DEVELOPMENT APPLICATION

PDPLANPMTD-2024/044606

PROPOSAL: Warehouse

LOCATION: 2 Lockheed Place, Cambridge

Vehicle Movement Notes
 Medium Rigid - Non-Articulated, Single Axle
 Vehicular Turning to the Loading Area Entering in a Forward Direction

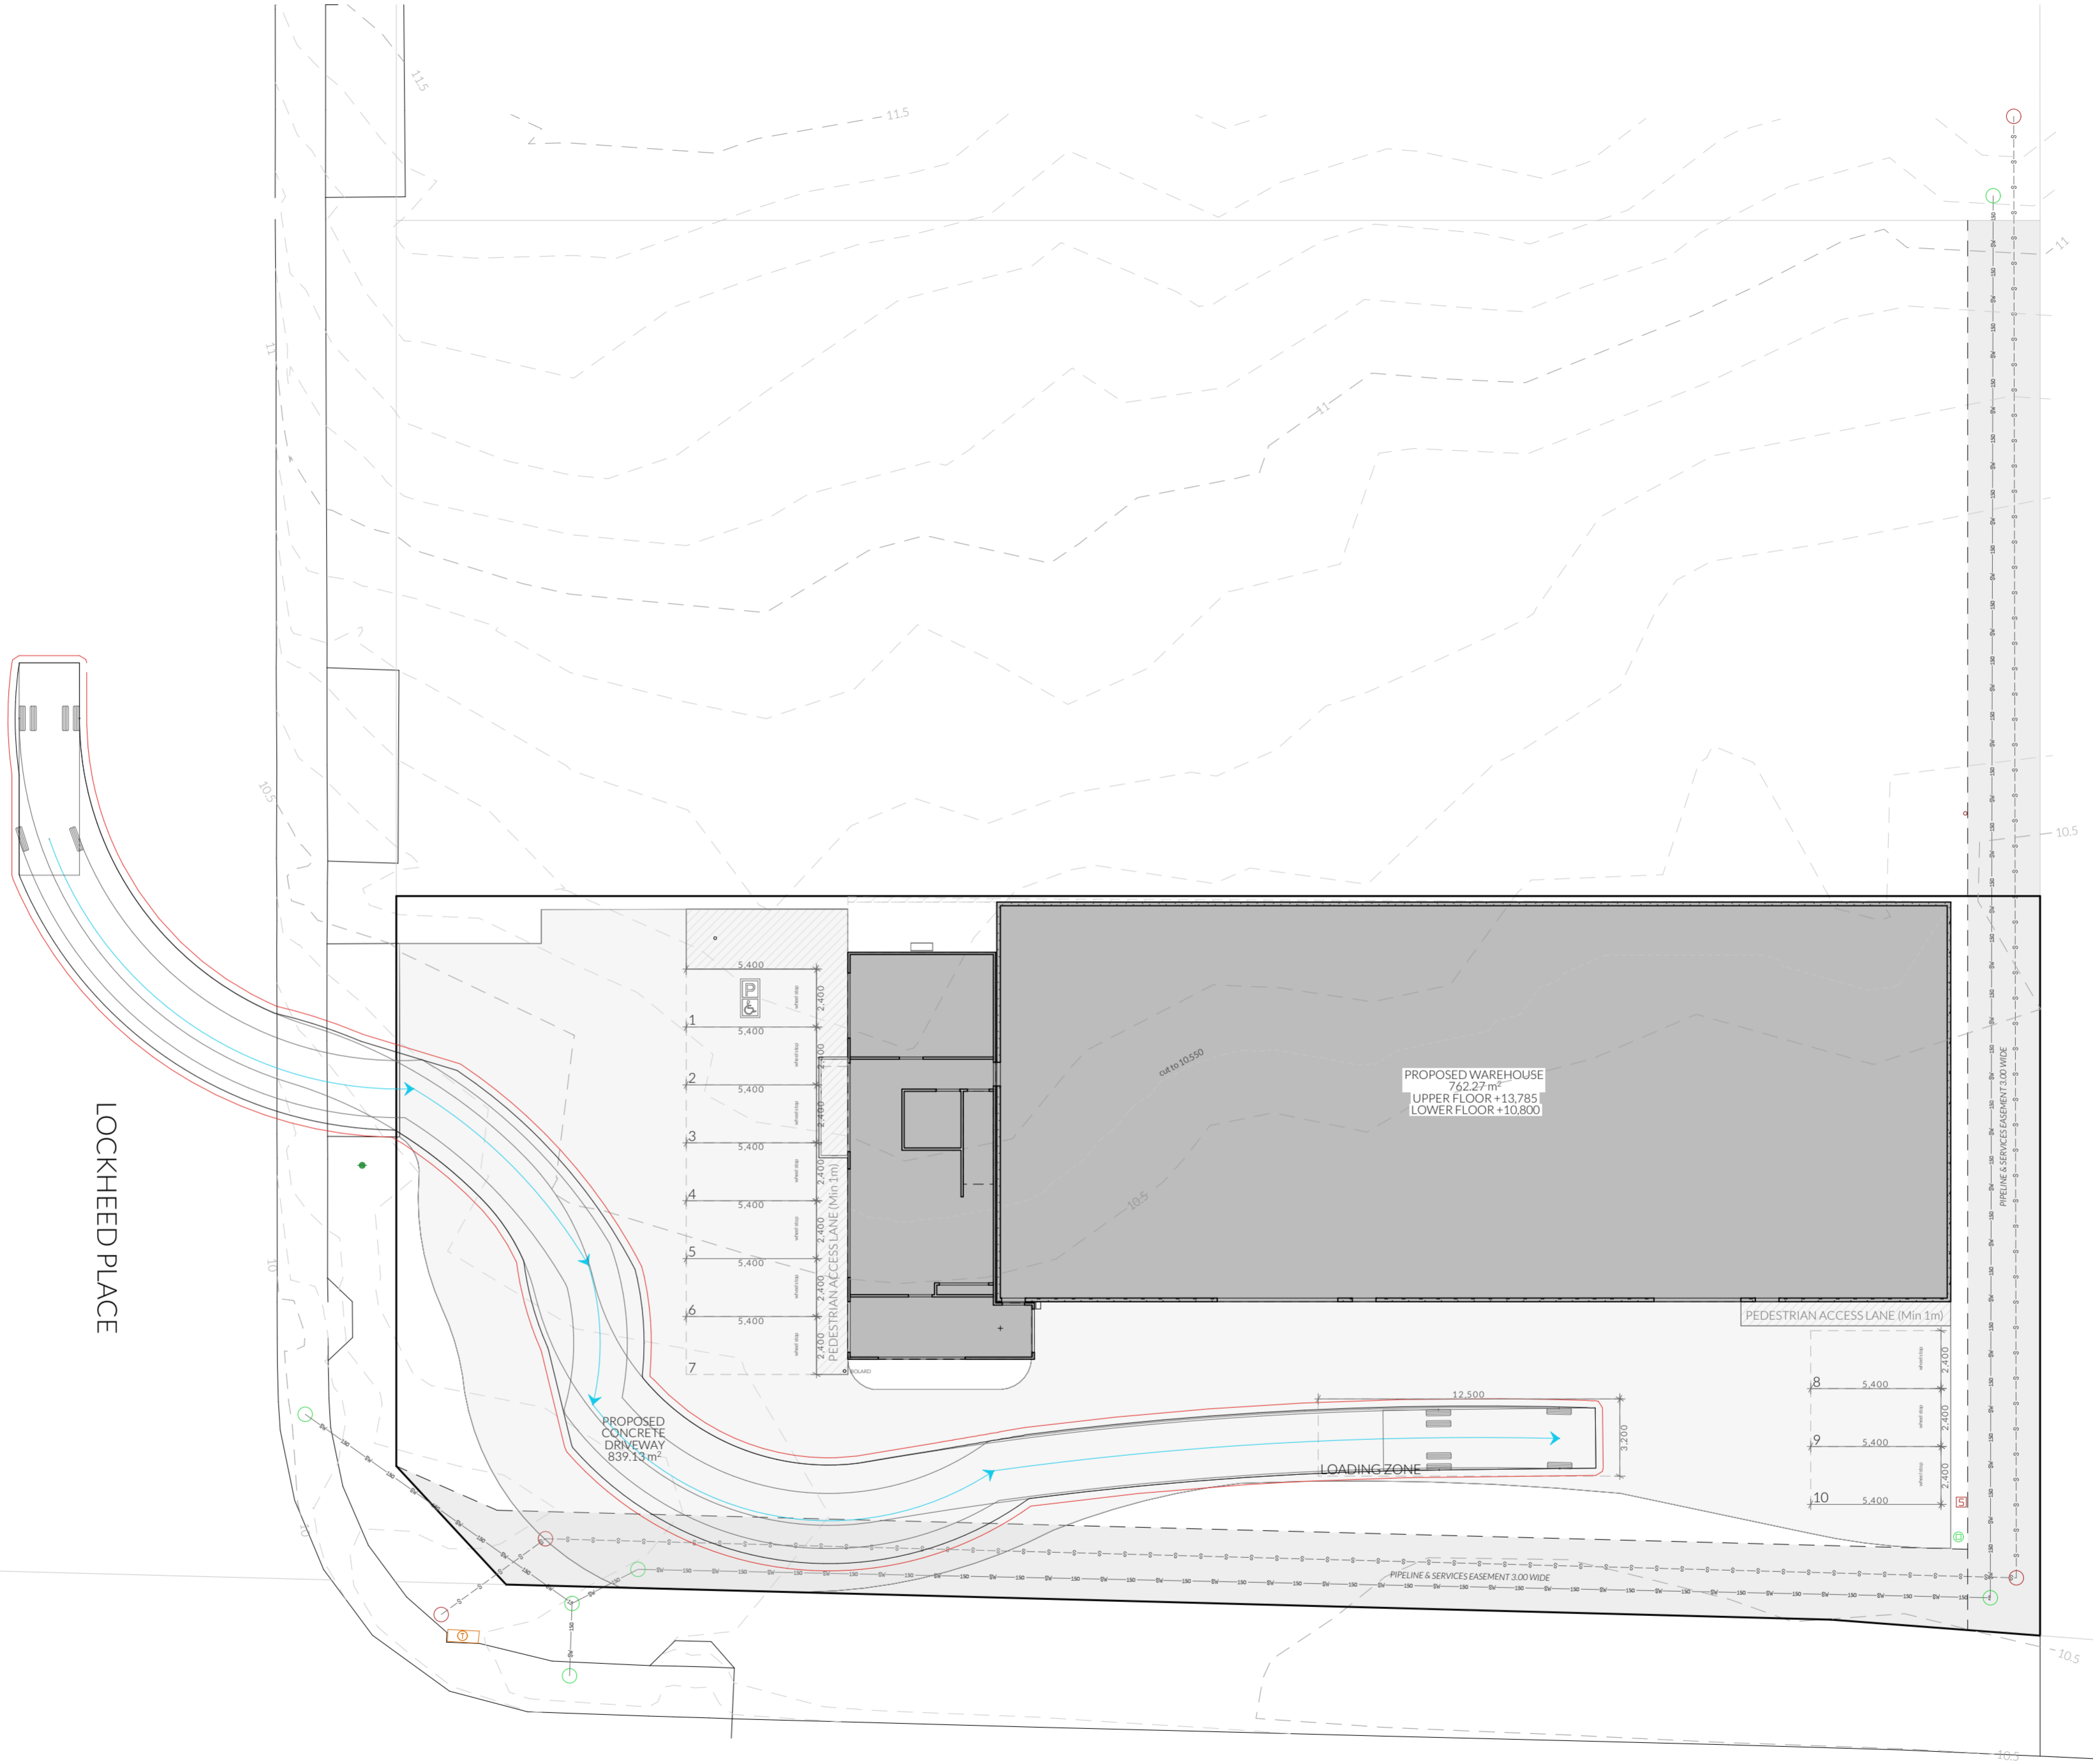
ITEM	COUNCIL REQUEST	DEVELOPMENT RESPONSE
C2.5.1	CAR PARKING NUMBERS, A1 To enable us to determine the required number of car parks provided for the use, please specify the anticipated number of employees associated with the proposed use.	Indications from the client are that they currently operate with 3 people in the warehouse area, and that including the office space that employees would not exceed 20 persons, which is in line with Table C2.1 Storage of "1 space per 200m ² of the site area or 1 space per 2 employees, whichever is greater" as there are 10 parking spaces provide on the site indicated on sheet A.01.
C2.6.6	LOADING BAYS, A2 Please specify intended vehicle usage. If designing for heavy vehicles, please provide documentation demonstrating ability to enter and exit the site in a forward direction. Please also demonstrate manoeuvrability of heavy vehicles from Bungana Way onto Lockheed Place and from Lockheed Place to the property, taking into consideration on-street parking.	Amended turning paths for a medium single axle non – articulated vehicle have been shown on sheet A.02 & A.03 as per operational requirements of the proposal.
